APPEAL APPLICATION

Regarding Case Number: DIR-2017-2942-DRB-SPP; CEQA: ENV-2017-2943-CE

Project Address: 1099 Westwood Boulevard; Los Angeles, CA 90024

**Re: Case No. DIR-2017-2942-DRB-SPP; CEQA: ENV-2017-2943-CE
1099 Westwood Boulevard; Los Angeles, CA 90024
Applicant: Artisanal Brewers Collective, LLC (dba Broxton)**

HISTORIC PHOTO
SHOWING ORIGINAL
MULTI-PANED
WINDOW

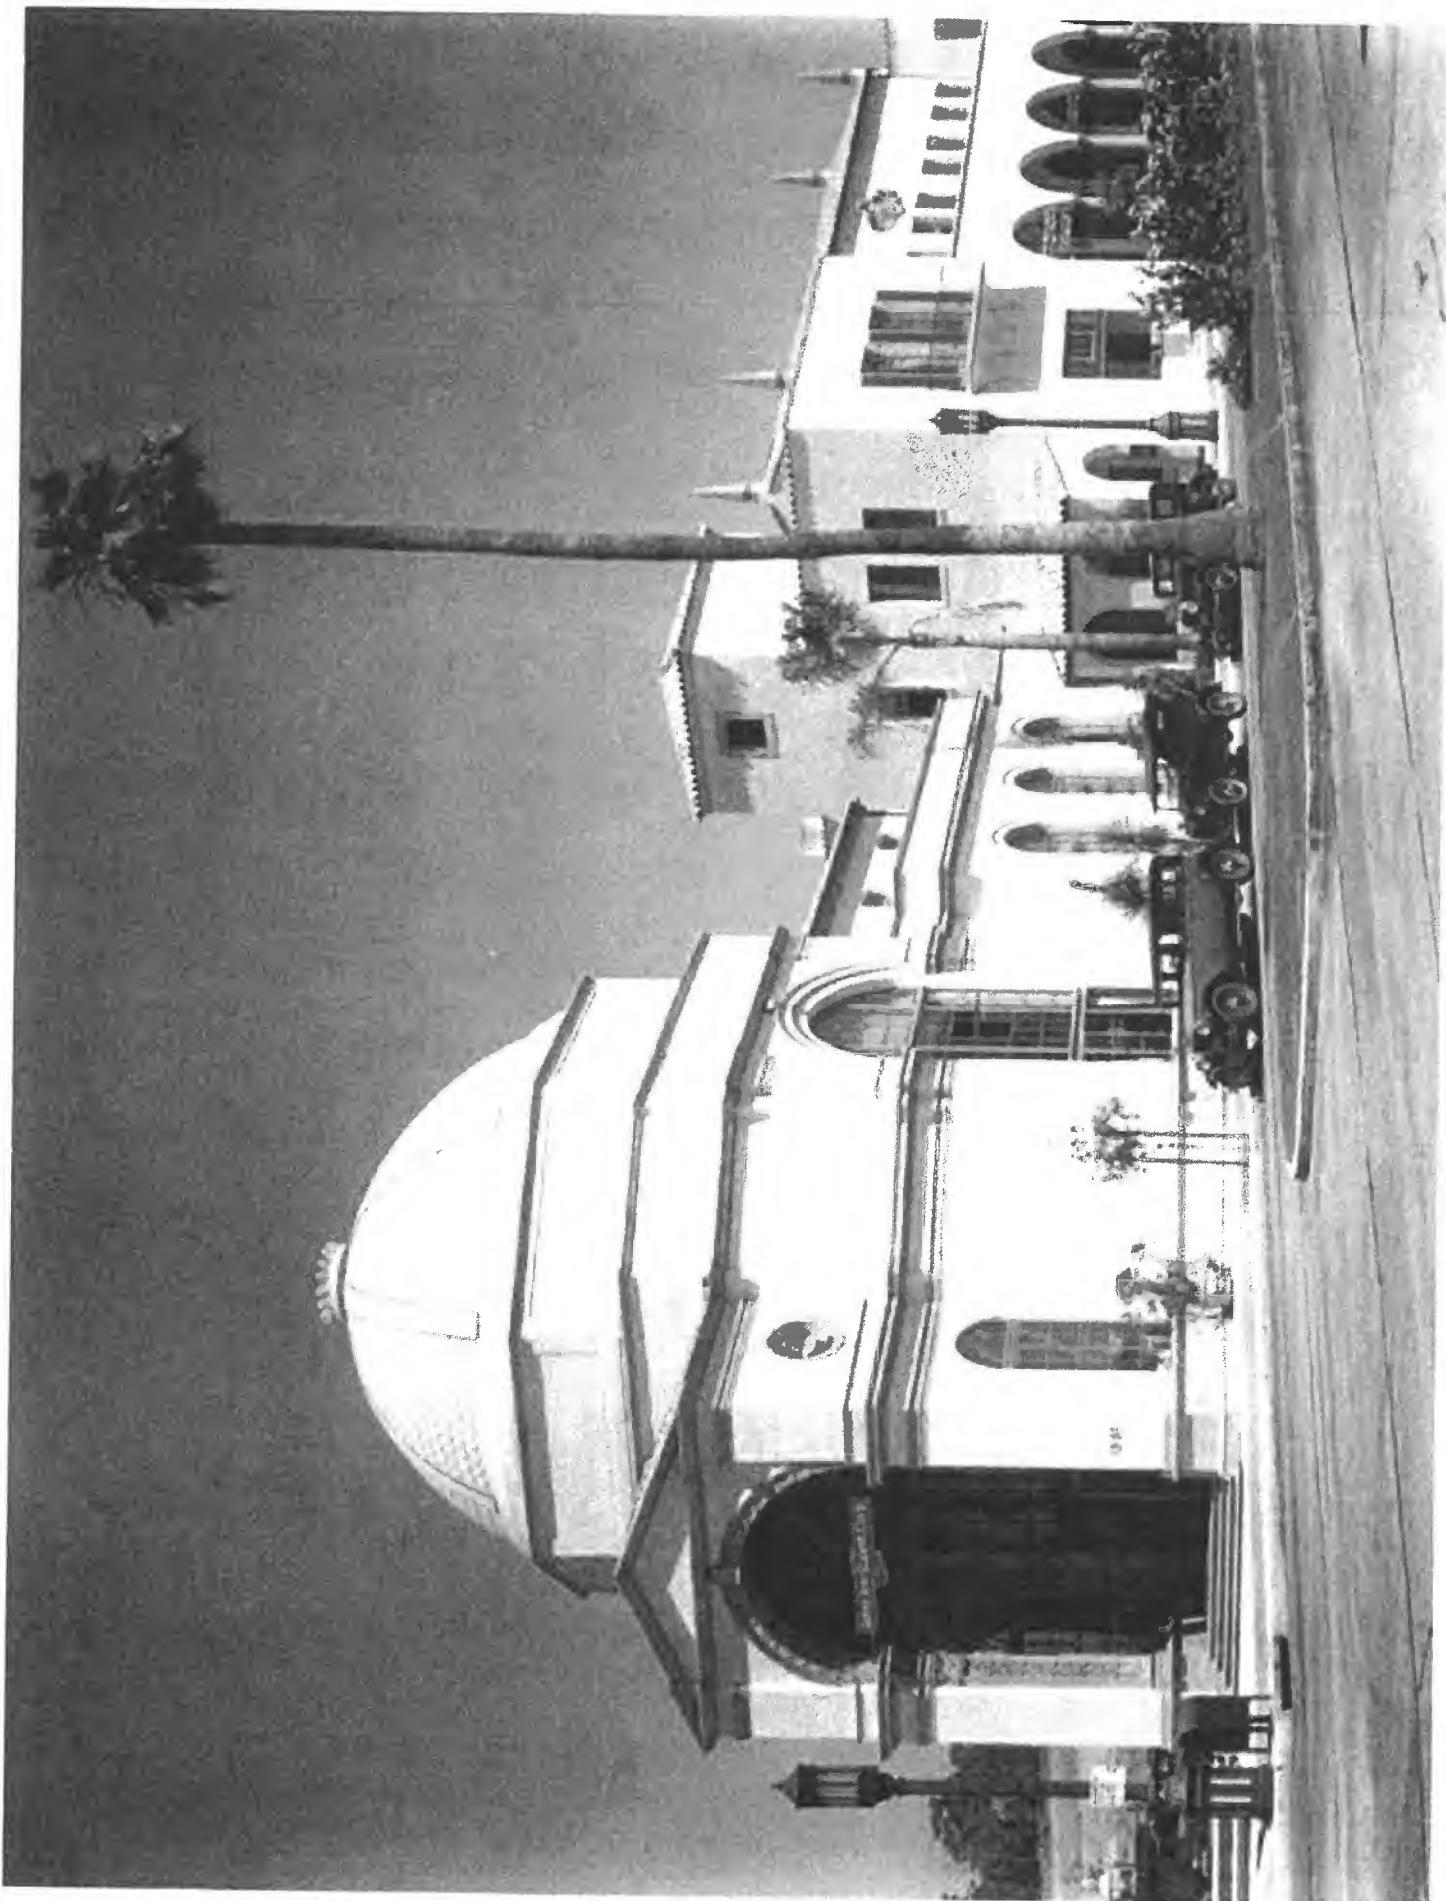
However, on BOTH sets of plans by the two different architects, the Applicant submitted plans to the Westwood Neighborhood Council showing their intention to repair and restore the partially altered and destroyed lower portion of one of the monumentally scaled arched windows contained in the Domed portion of the Rotunda, facing Westwood Boulevard.

EAST ELEVATION
15

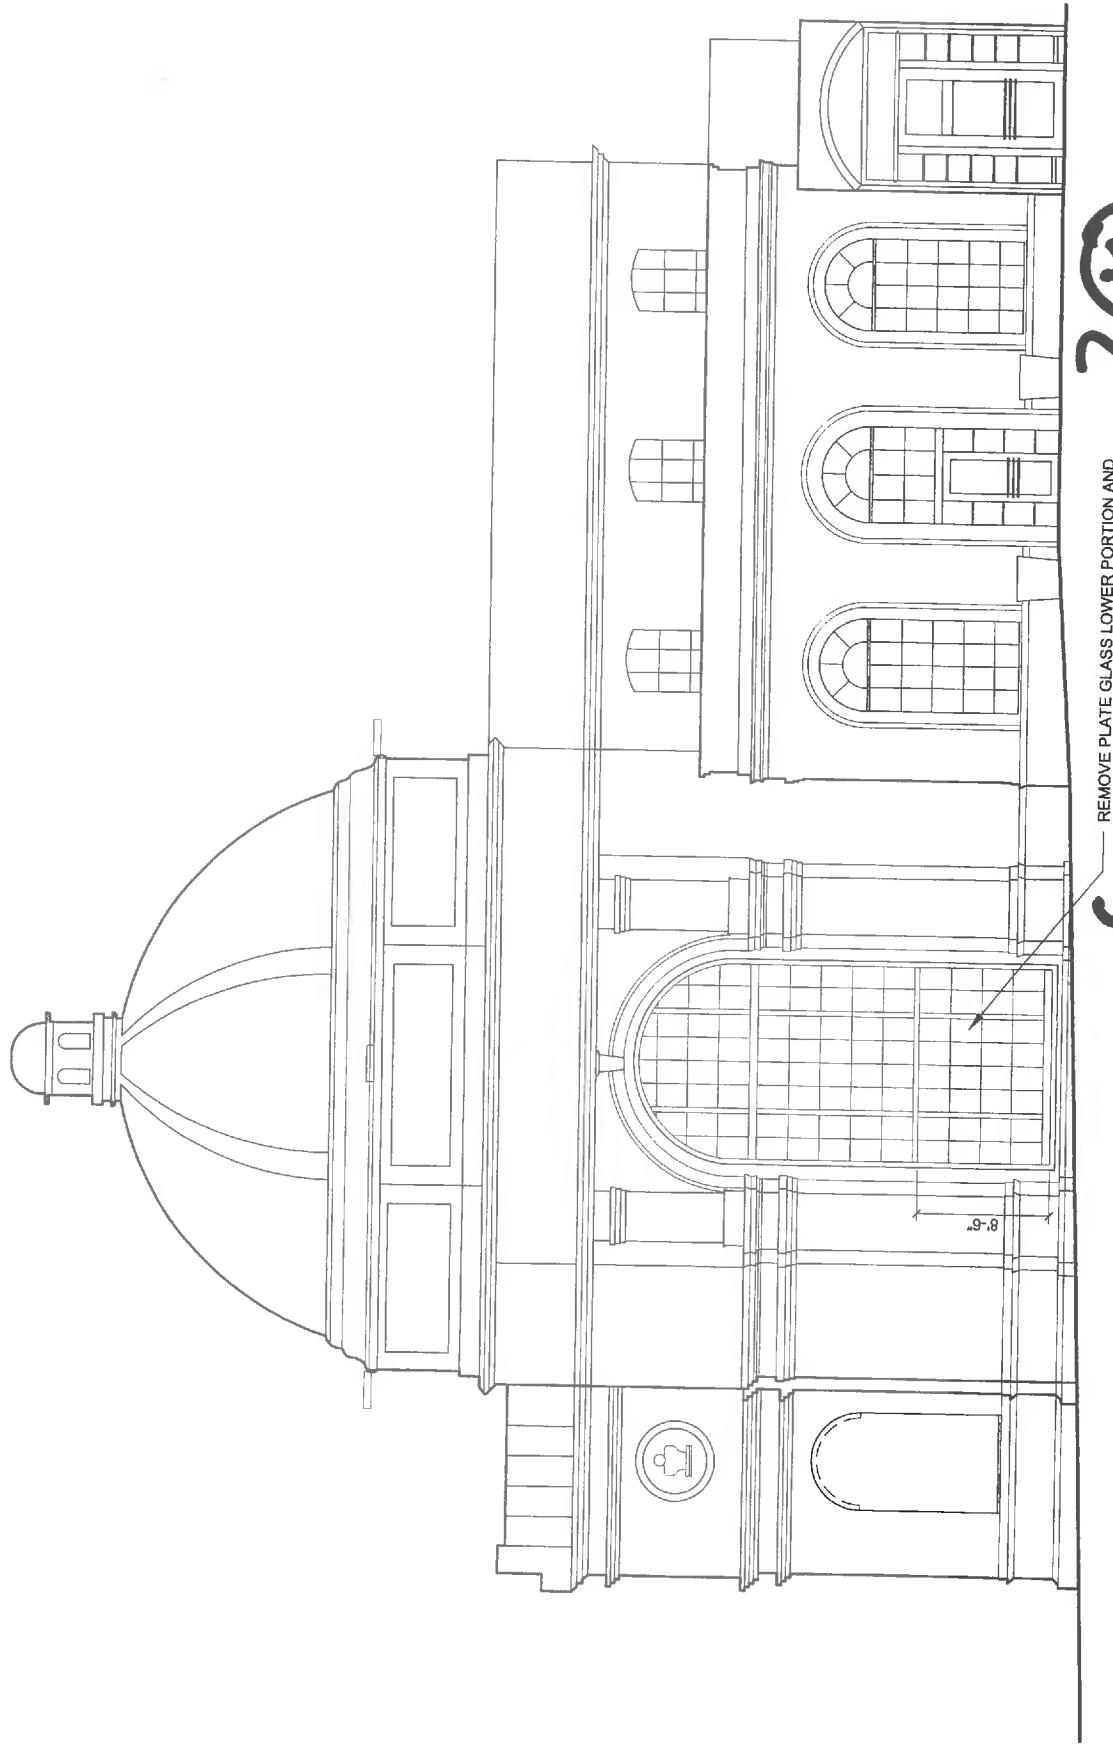
In fact, on Sheet 15 (“East Elevation”) in the Plans drawn by Anthony Eckelberry architect, which Plans were most recently submitted by the Applicant’s representative, Margaret Taylor, to the Westwood Neighborhood Council, these Plans include the following Note (written in ALL CAPS):

“REMOVE PLATE GLASS LOWER PORTION AND REPLACE WITH NEW STEEL STOREFRONT TO MATCH EXISTING”.

Said new steel multi-paned windows will essentially match the drawing of said plate glass section on Page 15 of the set of plans Applicant initially brought to the WWNC early in 2017 and not the drawing on Page 15 of the set of Plans filed with the DRB this past summer.

EAST ELEVATION

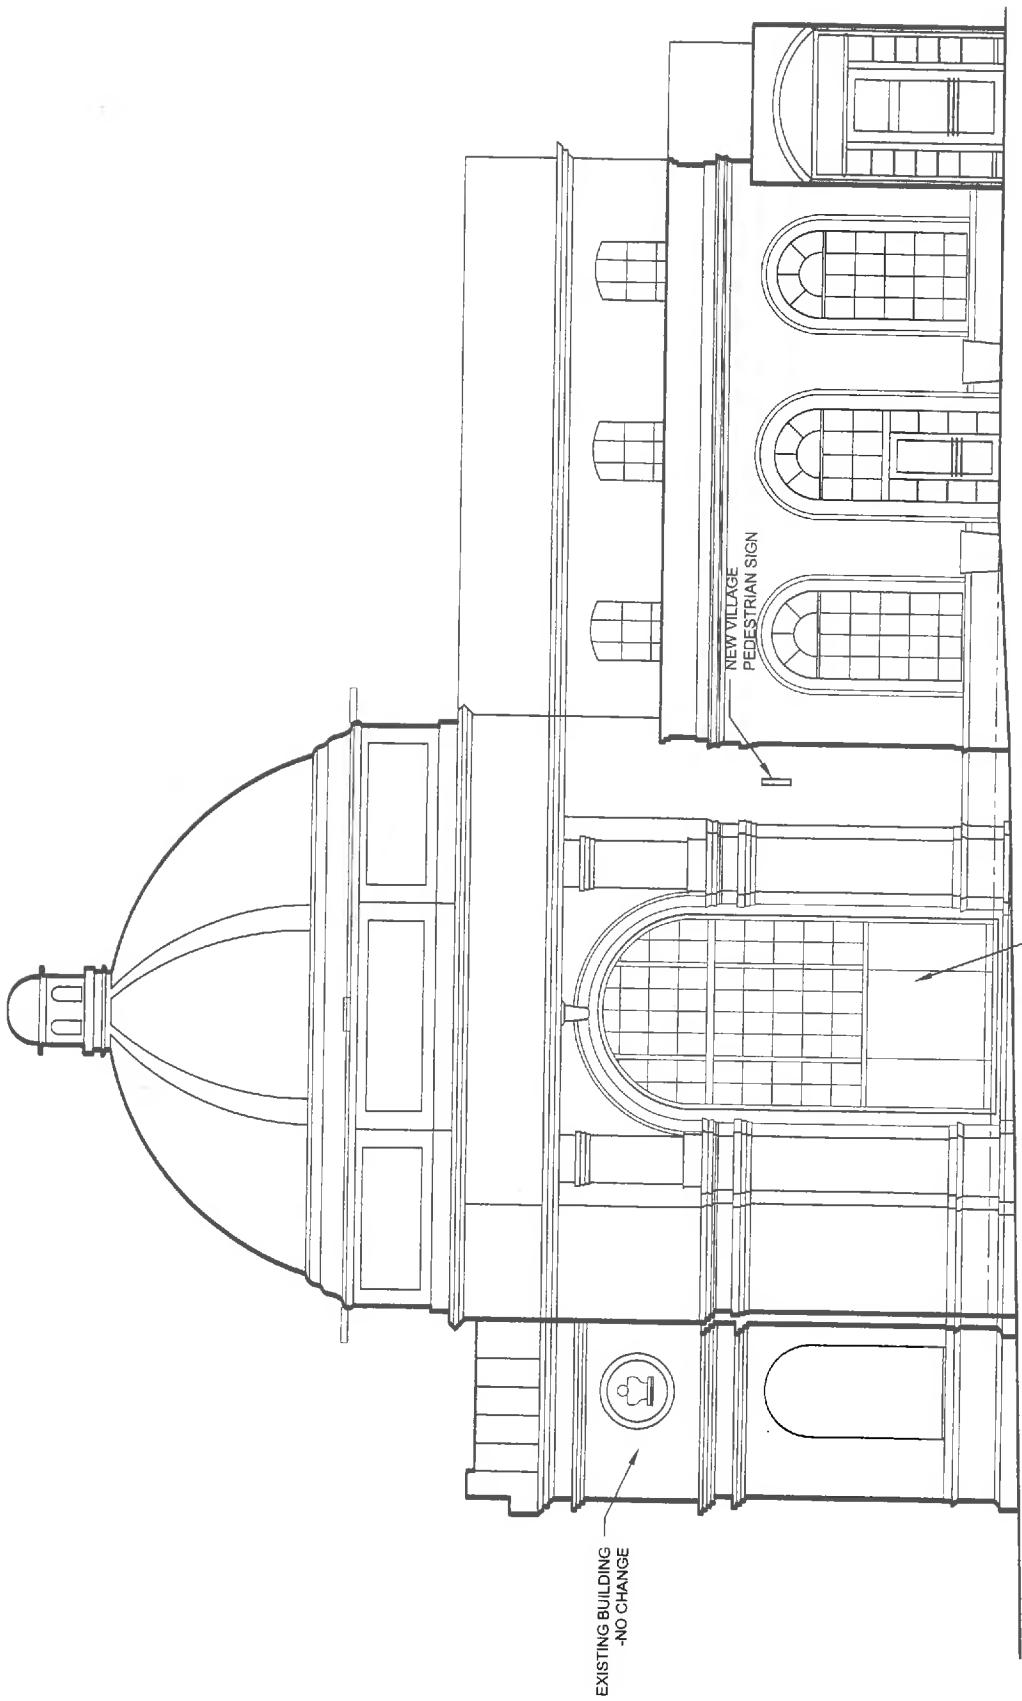
However, after receiving approval from the Westwood Neighborhood Council, the Applicant SWITCHED THEIR SET OF PLANS, and submitted a DIFFERENT SET OF PLANS to the Planning Department, which

altered set removed ALL plans, drawings, renderings, and notes referencing the repair and restoration of this character-defining feature shown to the Neighborhood Council.

ALTERED SET OF PLANS SUBMITTED BY APARTMENT TO
Planning's Office Thruout, Drawings NOT & Details
Contrary to with this Plan to Westwood N.C.
Exhibit 12 2012 Pictorial Book
